**BOARD OF ZONING ADJUSTMENT
STAFF REPORT****Date: November 4, 2013****CASE NUMBER**

5868

Jay Todia

918 Government Street
(North side of Government Street, 460'± West of Broad Street)

SITE PLAN

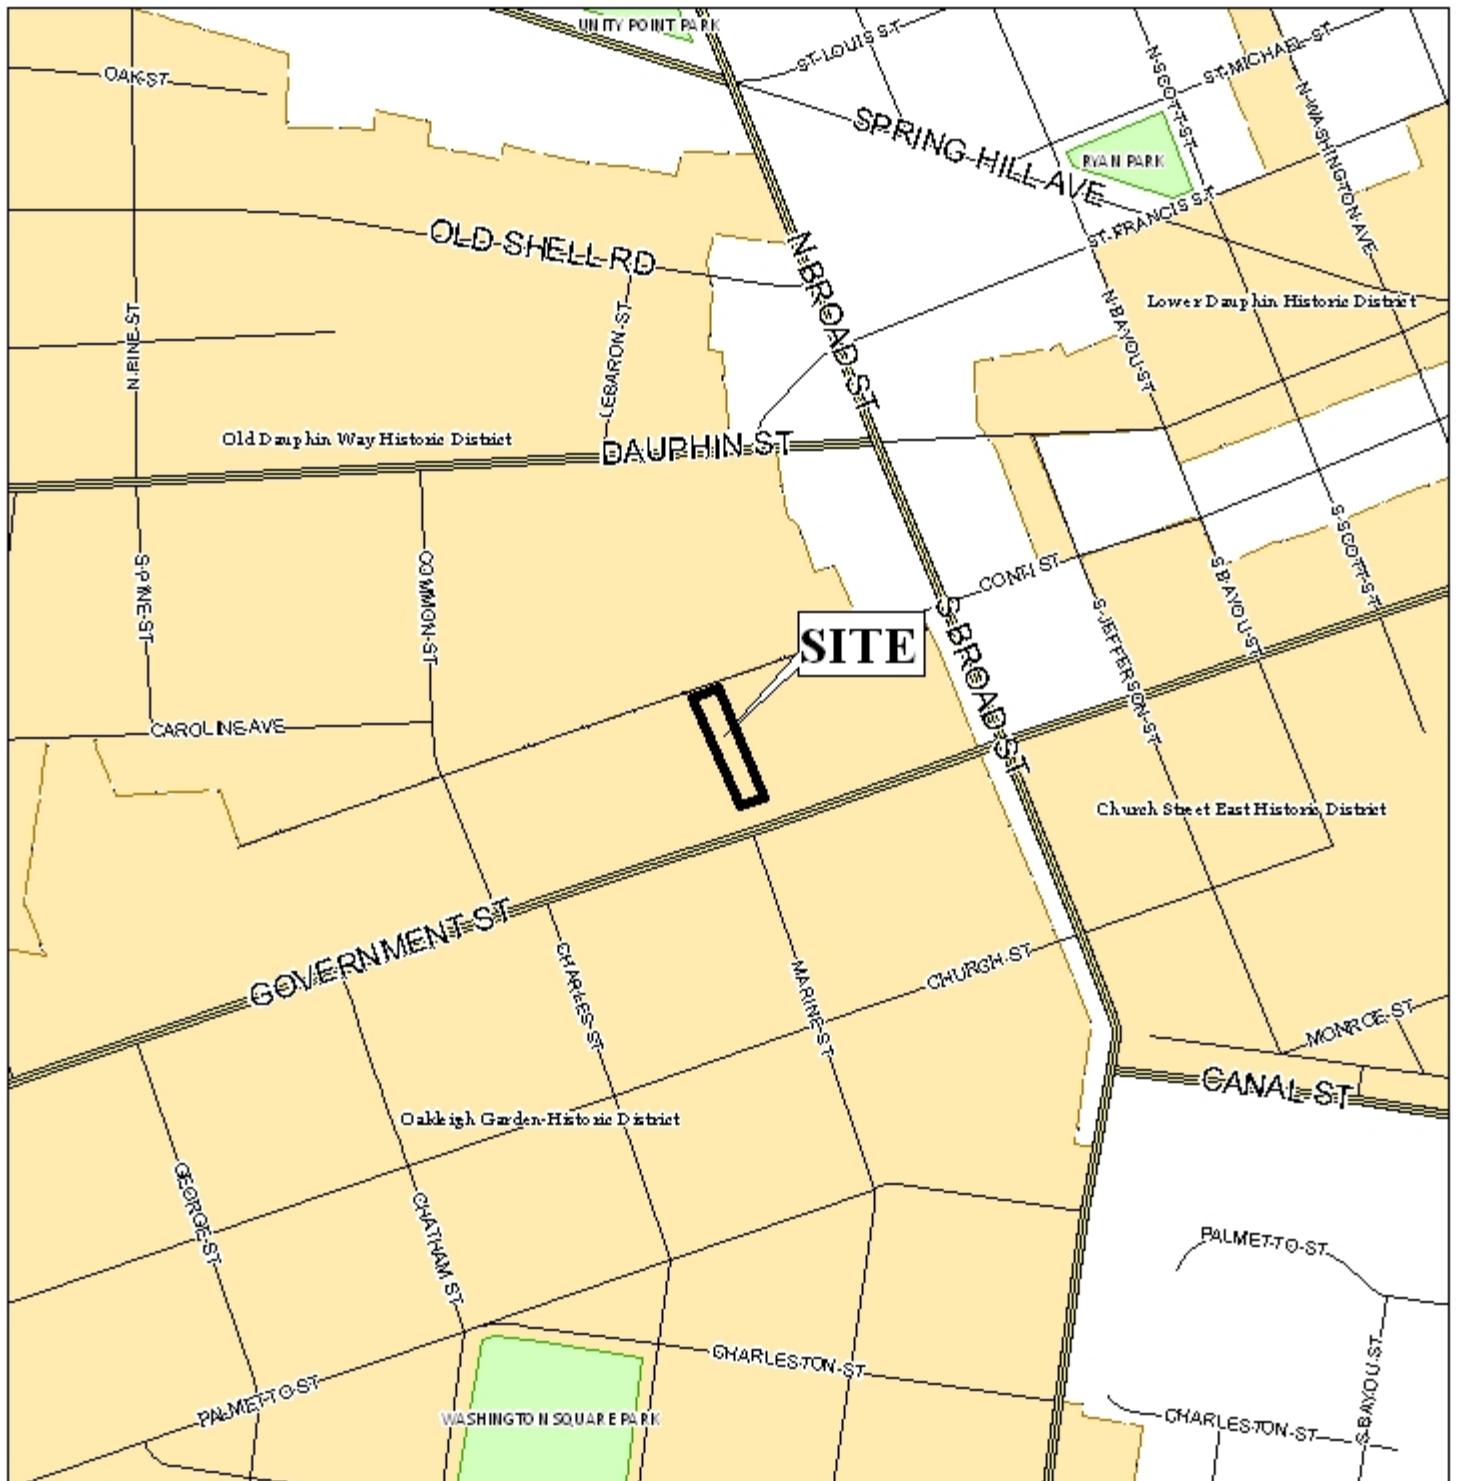
The shape of the parcel is not square, and the property narrows from Conti Street to Government Street. Therefore, at the middle of the property around the back of the building and the A/C units, the reduced width of the property is approximately 56' 10". With 2 rows of 18' parking spaces, the aisle width is reduced even more than the 21' 4", to approximately 20' 10". For reference purposes, sedans and mid-sized SUVs typically vary in length from 14' – 17', however a typical pick-up truck is around 20' in length. It is possible for vehicles to extend into the already reduced aisle width. If a variance is approved, the varying aisle width should be acknowledged to avoid variance compliance issues when a dimensioned site plan is submitted for approval. Also, bumper stops would be needed in the spaces along the east property line to prevent vehicles from encroaching or cutting through the adjacent property.

The site provides approximately a 21’-4” wide access/ maneuvering space for the parking area. The Zoning Ordinance requires a minimum of a 24’ wide maneuvering area for an area with two-way traffic. The narrow width of the lot prevents a 24’ wide maneuvering space unless the parking spaces are reduced in length from their compliant 18’. However it should be pointed out that due to the shape of the property the drive aisle will decrease as the aisle gets closer to the

building. The access/ maneuvering variance should be approved to allow a drive aisle no less than 20.5' as the aisle gets closer to the building. Based on this and previous approvals, it may be appropriate to grant this request.

It should be noted there is no dumpster illustrated on the site plan, nor is there a note stating that curbside pickup will be utilized. If approved, the site plan should be revised to either illustrate a dumpster in compliance with Section 64-4.D.9. of the Zoning Ordinance or place a note stating that curbside service will be utilized.

1. recommendation is contingent upon the verdict of the Planning Commission application for Planning Approval;
2. revisions to site plan to indicate a dumpster will be provided or a note on the plan stating that curbside pickup will be utilized;

3. subject to Urban Forestry comments: *"Due to existing trees located on right of way, at the front of the building, staff is recommending 1 overstory tree or 2 understory trees be planted on the Conti St. side and coordinate with Urban Forestry."*;

4. subject to Traffic Engineering comments: *"The shape of the parcel is not square, and the property narrows from Conti Street to Government Street. Therefore, at the middle of the property around the back of the building and the A/C units, the reduced width of the property is approximately 56' 10". With 2 rows of 18' parking spaces, the aisle width is reduced even more than the 21' 4", to approximately 20' 10". For reference purposes, sedans and mid-sized SUVs typically vary in length from 14' – 17', however a typical pick-up truck is around 20' in length. It is possible for vehicles to extend into the already reduced aisle width. If a variance is approved, the varying aisle width should be acknowledged to avoid variance compliance issues when a dimensioned site plan is submitted for approval. Also, bumper stops would be needed in the spaces along the east property line to prevent vehicles from encroaching or cutting through the adjacent property".;* and
